Amendments to the Drawings

The attached replacement drawing sheet contains proposed amended Figure 8. No new matter has been added.

Figure 8

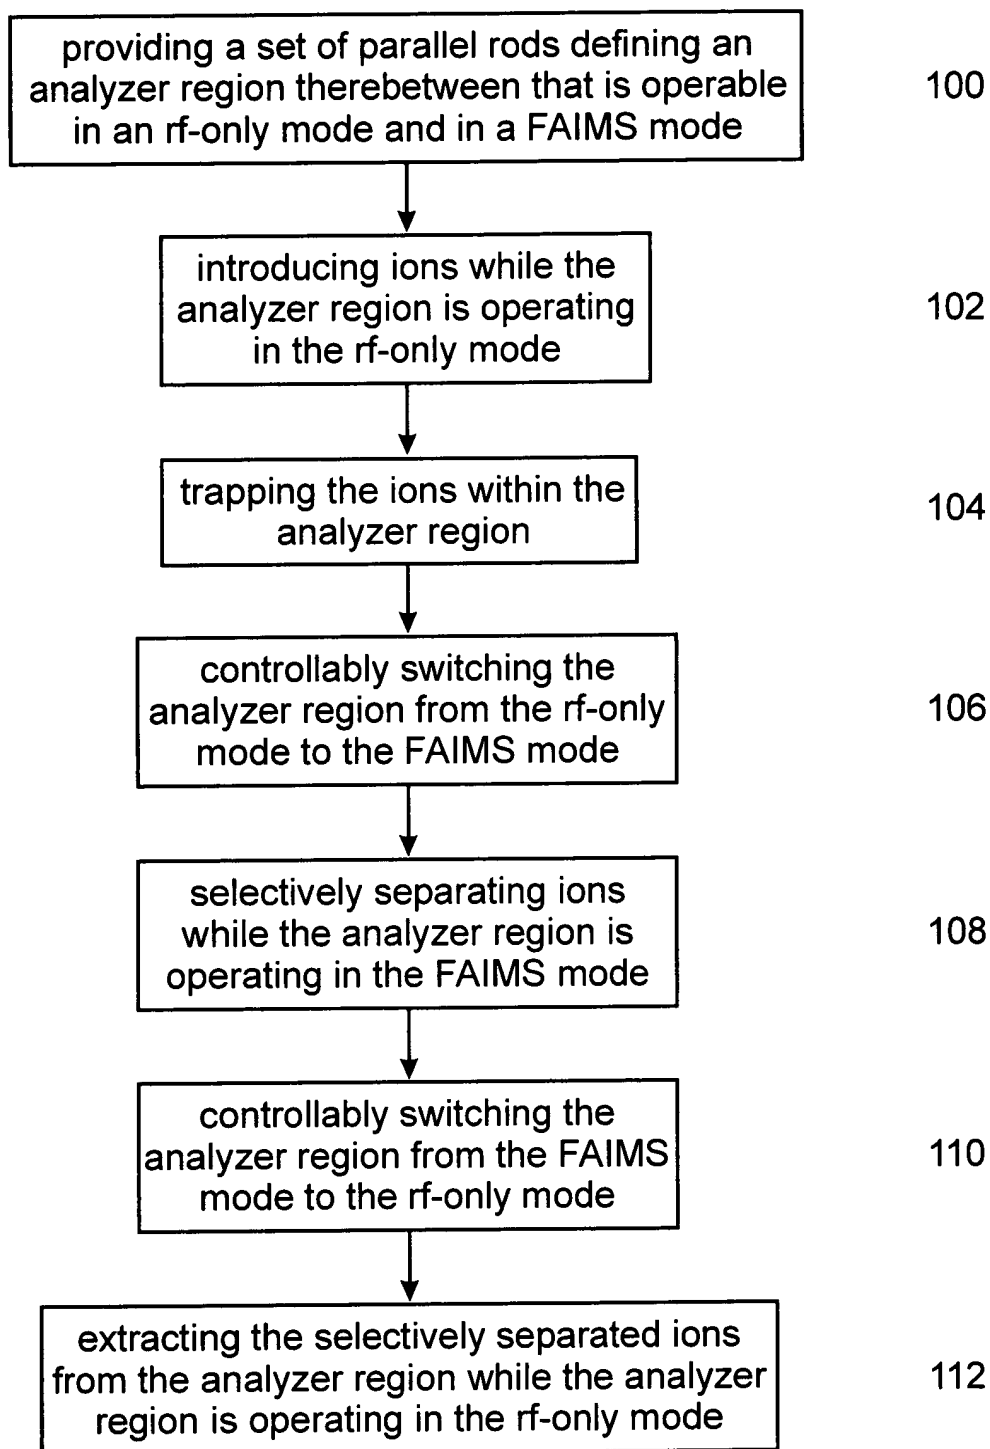
Figure 8 has been amended at step 110. In particular, the text “controllably switching the analyzer region from the rf-only mode to the FAIMS mode” has been amended to read -- controllably switching the analyzer region from the FAIMS mode to the rf-only mode--. Applicant respectfully submits that the proposed amendment to Figure 8 merely corrects an error of a clerical nature, which arose out of inadvertence. In particular, when the drawing sheet containing Figure 8 was prepared, the text appearing at box 106 was copied to box 110, but was not modified to agree with text appearing at paragraph [0093] of the application as originally filed. No new matter has been added.
